Reviewer 1:

Comment 1.1: CalMAPLab is a Ford Transit 250 retrofitted as a research-grade mobile air-quality laboratory, built around a strong contemporary instrument payload (Vocus PTR-ToF-MS, dual Aeris Mira Ultras, LI-7200, CAPS, EcoPhysics nCLD, 2BTech O₃, Fidas, AE33, CPC, Spider-MAGIC) and supported by VanDAQ, a custom open-source data acquisition and user interface framework. The vehicle and electrical integration are modern, and with 500+ hours of test driving the platform clearly works as intended. The manuscript has three problems the current draft does not adequately address. The novelty claim does not hold up against an existing literature the authors do not cite. The most distinctive piece of work, VanDAQ, is documented at a depth that does not match its novelty. The hardware description is precise enough to convince a reader the system works but not precise enough to let another group build one.

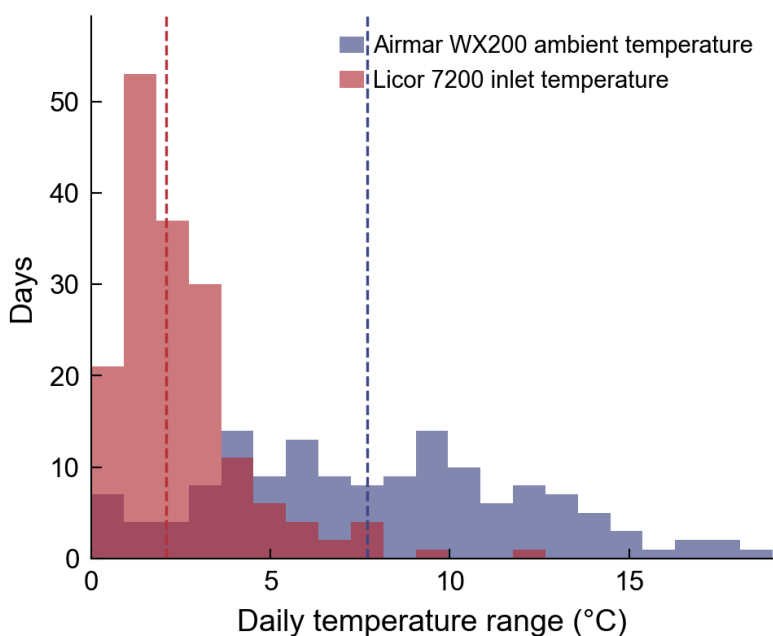
Comment 1.12: The Mira Ultras, CAPS, and Vocus are temperature-sensitive, and the sample lines run between an interior climate-controlled volume and a roof-mounted ambient inlet. The transient thermal response of the lines as the van moves between, say, a 35 °C parking lot and a 12 °C coastal fog bank is not addressed.

Response: We thank the reviewer for raising sample line thermal transients. The inlet draws ambient air into a van maintained at $\geq 23 \text{ °C}$. Analysis of the test dataset showed the median daily roof temperature range as measured by the Airmar weather station was 7.7 °C (min = 0.3 °C, max = 22.4 °C). Sample gas temperature is measured by the Licor 7200 CO₂. In comparison to ambient temperature, the median daily sample gas temperature range during operation was measured as 2.1 °C (min = 0.1 °C, max = 12.4 °C). This indicates a strong thermal buffering relative to roof ambient temperature and consistent sample line temperatures throughout operation. For uncorrected air density-sensitive measurements, biases are estimated at ~1%, rising to ~3 % on the days with the greatest temperature variability. Within our instrument payload, these are largely accounted for through measured cell temperature and subsequent internal corrections.

We also do not experience any condensation issues from sampling close to the dew point temperature. Sample dew point was at least 5 °C below the van internal temperature 100% of the time. However, we do note that should sampling take place in more humid environments, heating the sample line is an important consideration.

This discussion has been added to the Section 3.1 text, and a figure highlighting the sample line thermal buffering has been added to the SI.

“Some atmospheric measurements are sensitive to the density and therefore temperature of the sample gas. To assess thermal transients along the sampling path, we compare roof ambient temperature with sample gas temperatures reported at the cell inlet of the Licor 7200. On average, the median daily temperature range on the roof was 7.7 °C (min = 0.3 °C, max = 22.4 °C) whereas median daily ranges at the Licor was 2.1 °C (min = 0.1 °C, max = 12.4 °C, see Fig. S11 for more detail). These results indicate substantial thermal buffering of sample air relative to roof ambient, consistent with heating and residence time in the climate-controlled cabin rather than directly tracking outdoor temperature. For uncorrected density-sensitive measurements, biases are estimated at ~1% rising to ~3% on the days with greatest temperature variability. Within our instrument payload, these are largely accounted for through measured cell temperature and subsequent internal corrections. In addition, no condensation issues were encountered where sample dew point was at least 5 °C below the van internal temperature 100% of the time. However, we do note that should sampling take place in more humid environments, heating the sample line is an important consideration.”

“Figure S12: Stability of calibration slopes over ~8 months of operation for a) O₃, CH₄, C₂H₆, N₂O, CO, NO, NO₂, NO_x and CO₂, and b) the Vocus k_{sens} vs k_{PTR}.”

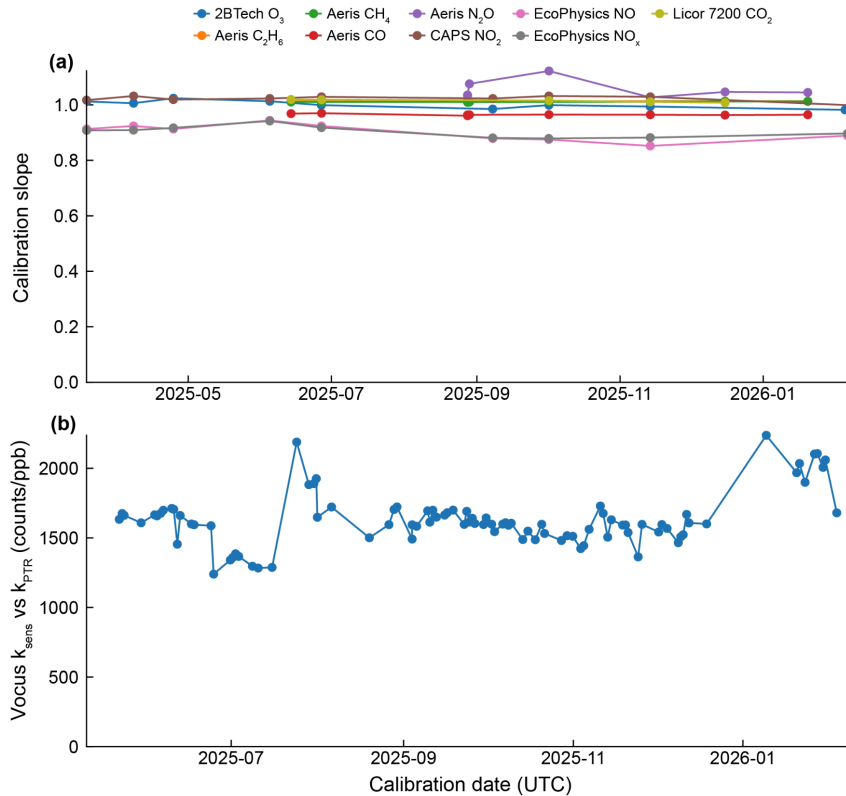
Comment 2.9: L130: how stable are the calibrations? I do not see any example calibrations here or in the supplement.

Response: Calibrations are very stable across 8 months of testing and a figure has been added to the SI to highlight this.

“Much of the instrument payload was chosen based on past reliability in mobile applications (Apte et al., 2017; Harlass et al., 2024; Ma, 2021; Padilla et al., 2022; Shah et al., 2023) and long-term stability was observed in the calibration factors across the testing time period (see Fig. S12).”

Figure S6: Measured engineering parameters can be studied by clicking on each instrument to open a second set of time series. As with Figure S5, parameter alarms triggered due to a measurement being out of range flash red. The example here is T2 on the Aeris CO/N₂O instrument.

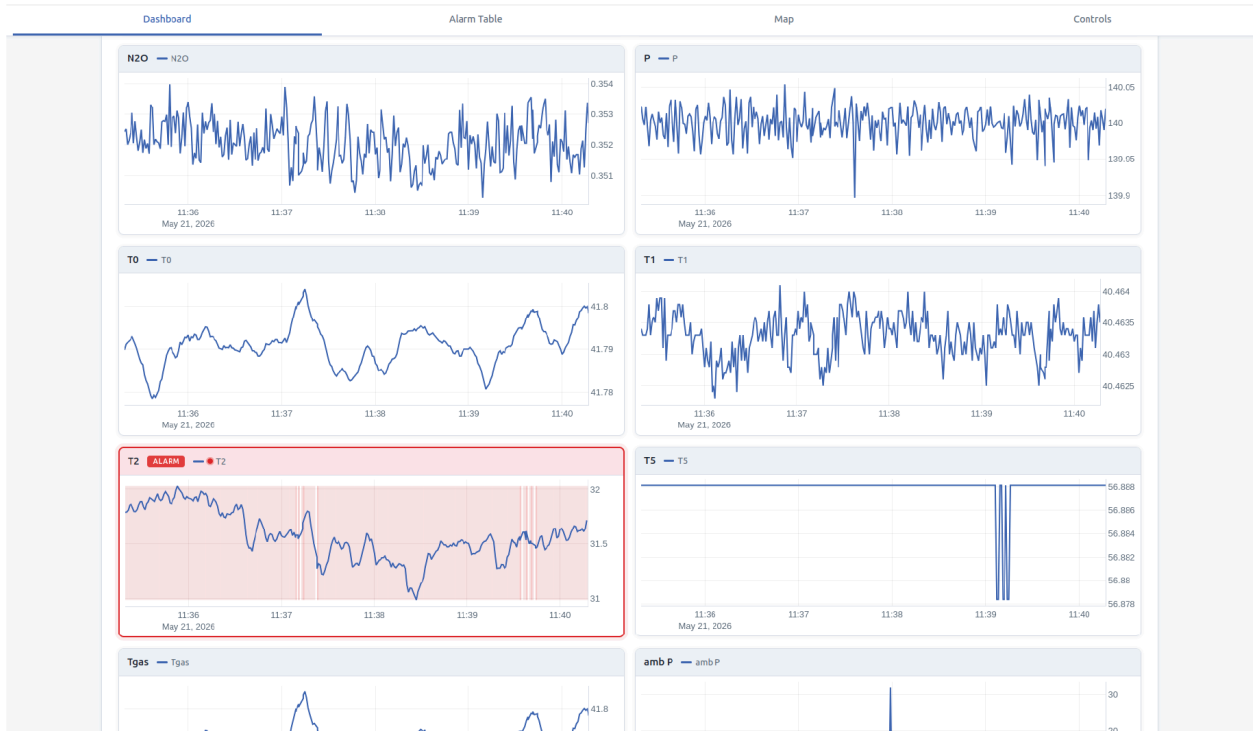
1. Changed the dashboard design for a sleeker look. See below the new supplementary figures that replaced Figure S2.
